# **STATEMENT OF ENVIRONMENTAL EFFECTS**

**39-41 Chertsey Avenue, Bankstown NSW 2200**

**S4.55 AMENDMENTS TO DA-1013-2015**

**FOR THE APPROVED DEVELOPMENT APPLICATION OF A  
RESIDENTIAL FLAT BUILDING AND BASEMENT CAR PARKING  
UNDER STATE ENVIRONMENTAL PLANNING POLICY  
(AFFORDABLE RENTAL HOUSING) 2009**

Figure 3: S4.55 ARH Calculations

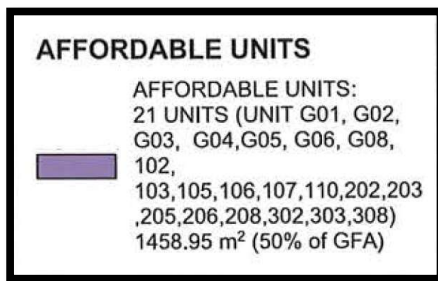
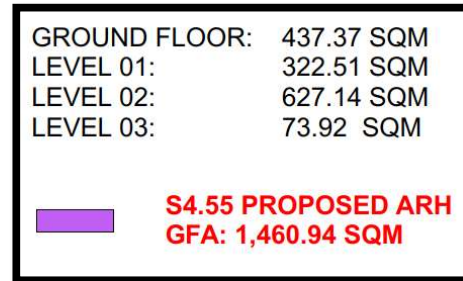
1. Re-allocation of Affordable Rental Housing (ARH) Units and calculations for the development.
  - Removal of Units from the ARH Allocations
    - Unit G01, Unit 103, Unit 106, Unit 108, Unit 302 & Unit 303
  - Addition of Units to the ARH Allocations
    - Unit G07, Unit 109, Unit 201, Unit 204, Unit 207 & Unit 209

In accordance with the Development Approval for Gross Floor Area (GFA) and Floor Space Ratio (FSR) Calculation, a bonus of 0.5 Affordable Rental Housing (ARH) units has been applied to the development consent. The development must provide the minimum GFA allocation of 1,420.98m<sup>2</sup> (50% of the Approved GFA: 2,841.96m<sup>2</sup>).

The proposal is to re-allocate the ARH units while ensuring compliance with the minimum requirements as per the Development Approval (DA)-approved Gross Floor Area (GFA) of 1,458.95m<sup>2</sup>, which aligns with the S4.55 proposed ARH allocation of 1,460.94m<sup>2</sup>. This results in an excess of 39.96m<sup>2</sup> than the minimum ARH required for the development.

Figure 4: South Elevation – Streetscape View (Front)

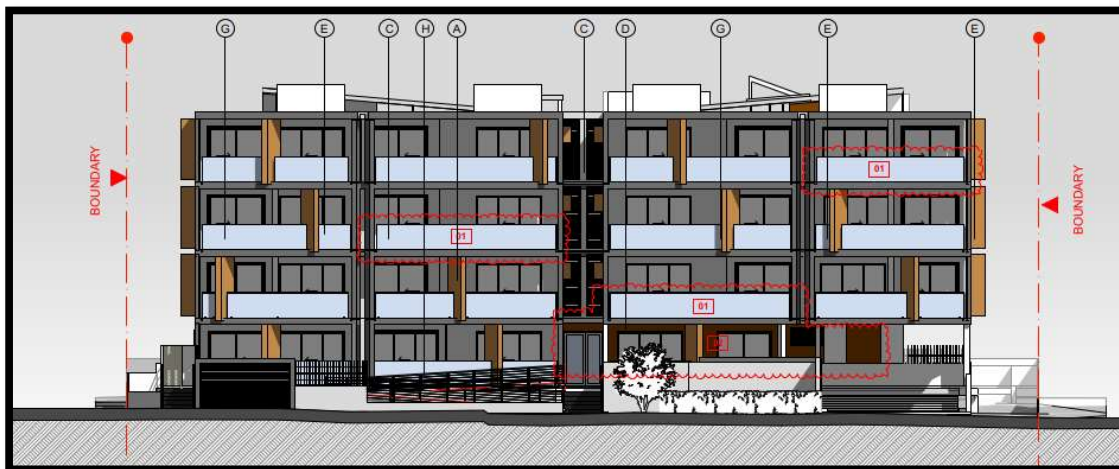
The proposal seeks to remove the solid balcony balustrades on the south elevation of the development, thereby providing a consistent façade feature that aligns with the modern appearance and characteristics of both the development and other surrounding modern buildings in the area.

The proposed change is minor in nature and adheres to the Canterbury-Bankstown Council Development Control Plan (DCP) 2023 Section 8 objectives of minimising blank walls, visual bulk, and ensuring access to sunlight, as well as contributing to a high-quality streetscape and amenity.

Figure 5: West Elevation (Side)

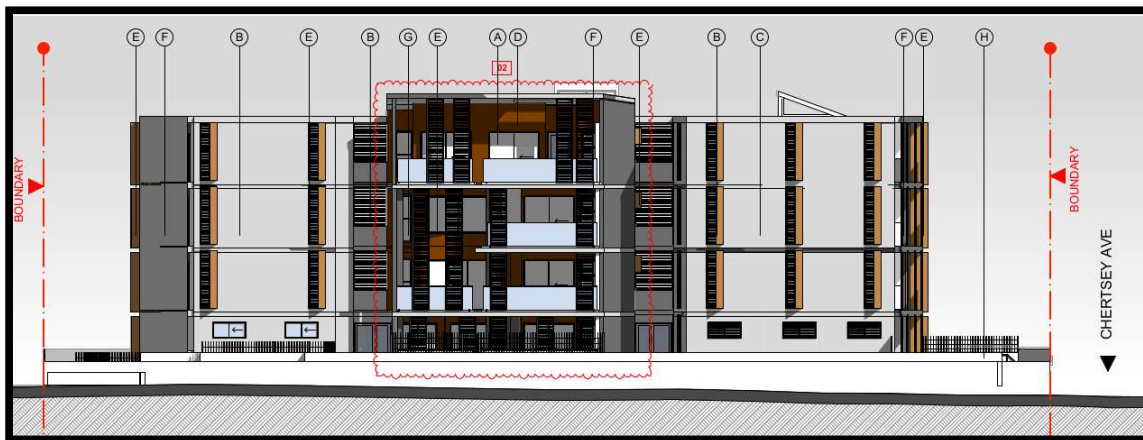
The proposal seeks to replace the DA-approved face brick external wall finish with a rendered paint finish to enhance the building's overall consistency, and constructability

The proposal intends to retain the brown or similarly coloured finish to the exterior in the locations where it will replace the brick finish, ensuring minimal adverse impact on the building's overall appearance, neighbouring properties, and the streetscape view.

**Figure 7: S4.55 Proposed**

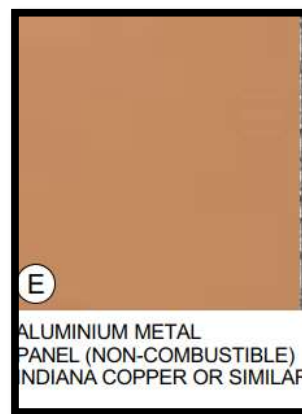
The proposal seeks to remove the use of "Alucobond PE Aluminium Metal Cladding Flatlock Panels" within the development as per the DA approval. This is due rising concerns in the market and compliance with the National Construction Code (NCC) for the use of combustible aluminium bonded laminate panels (BLM).

To mitigate issues related to combustibility, we seek to remove the specified Alucobond manufacturer name in the approved Schedule of Finishes with a typical "Non-combustible Aluminium Panel" with a similar colour (finish), that will be provided subject to manufacturers availability or market supply during installation in accordance with the NCC.
